Addendum No: 3  
Date: January 19, 2024  
Owner: Northern Health  
Stantec # 144320228

Project #CI21181  
UHNBC  
PHARMACY NAPRA UPGRADES

Issued for Tender – Addendum #3

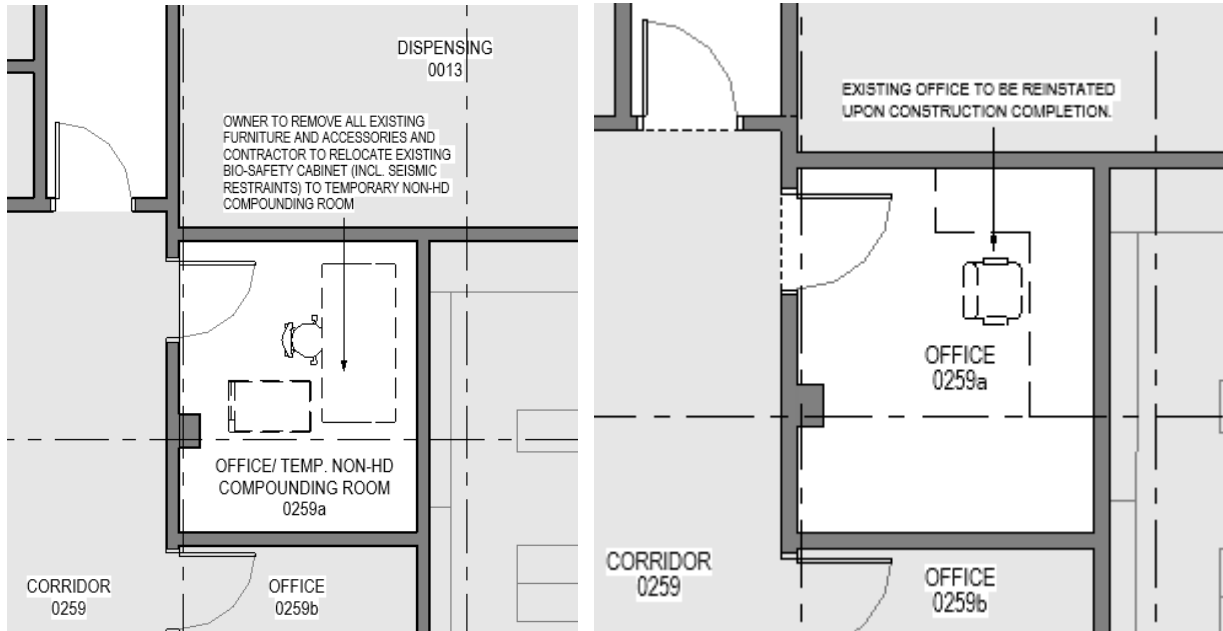
Question. The New EF's and AHU require new breaker buckets in the MCC – 10E. There does not seem to be enough room for the brakers. Please confirm.

Answer: Refer to photo below circled area, 18” mounting space is available for three of 3phse 3 wire breakers, using “Compac 6 unit” (Schneider). Please inform owner and consultant if these spaces shown in photo are not available anymore.

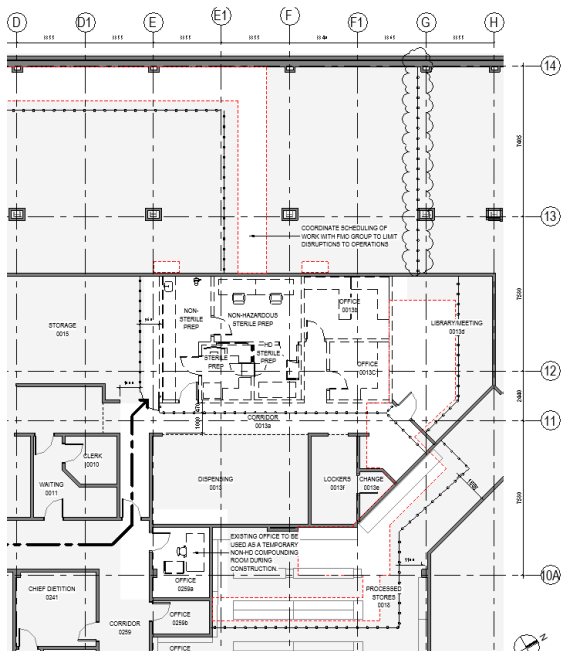
Question: the hoarding requirements show on AE001 do not capture all the ducting that is shown on M102 for the area around bay line 13 and between E and G. Please confirm the hoarding extents for the mechanical and electrical in these areas.

Answer: Yes, hoarding to extent as needed to cover the working area.
